Re: Unorthodox Coal Gas Well Location
~~Northeast Blanco Unit No. 424~~
2073' FNL, 1330' FWL
E, Section 4, T30N, R7W
Basin Fruitland Coal Pool
San Juan County, New Mexico

SUNDRY NOTICES AND REPORTS ON WELLS

9. WELL NO.
424

Northeast Blanco Unit #424
2100 FNL, 1330 FWL
Sec. 4, T30N, R7W N.M.P.M.
San Juan Co., N.M.

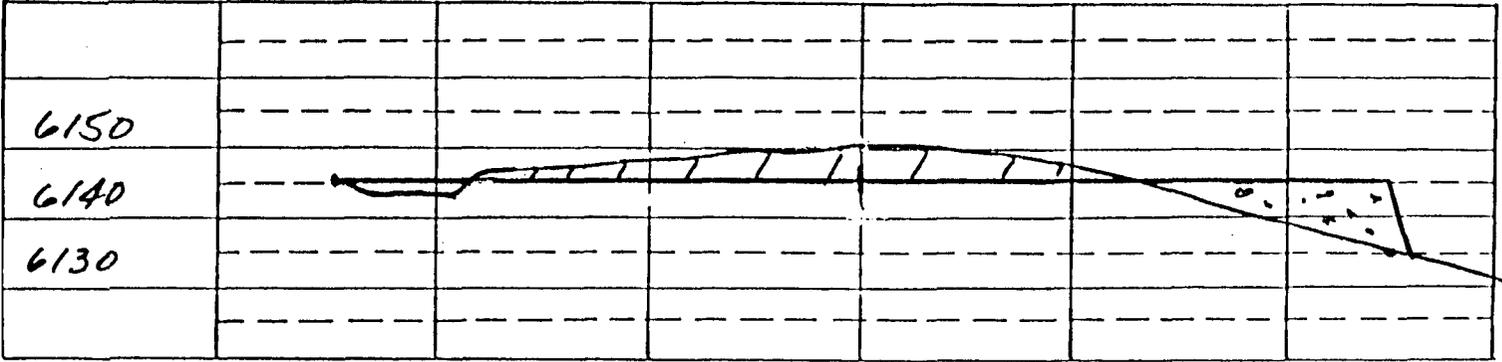
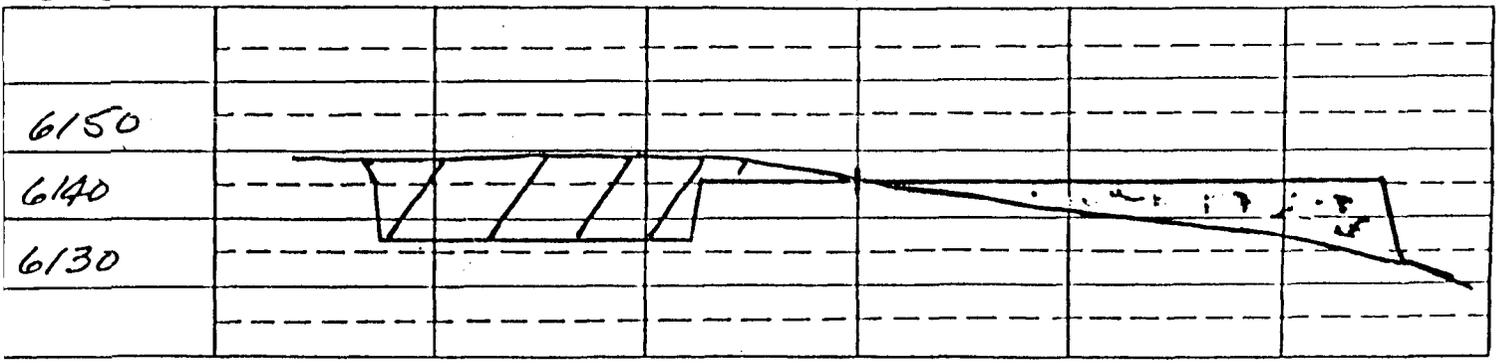
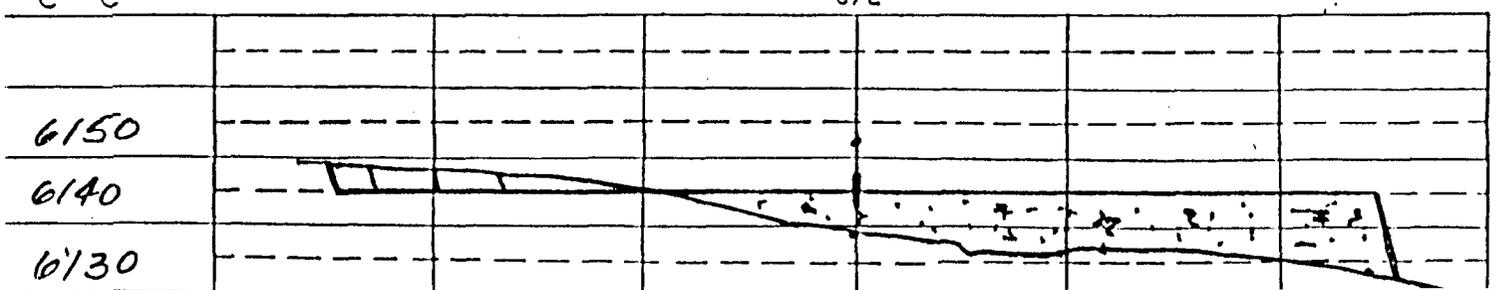
Propose to change footage location and layout as shown on the attached cut & fill diagram. All cuts and fills will be outside the staked perimeter, but within the construction zone. Corners 2, 3, and 6 will be at steep slopes to avoid treeline and archaeology site.

New footage location to 2075' FNL, 1330' FWL
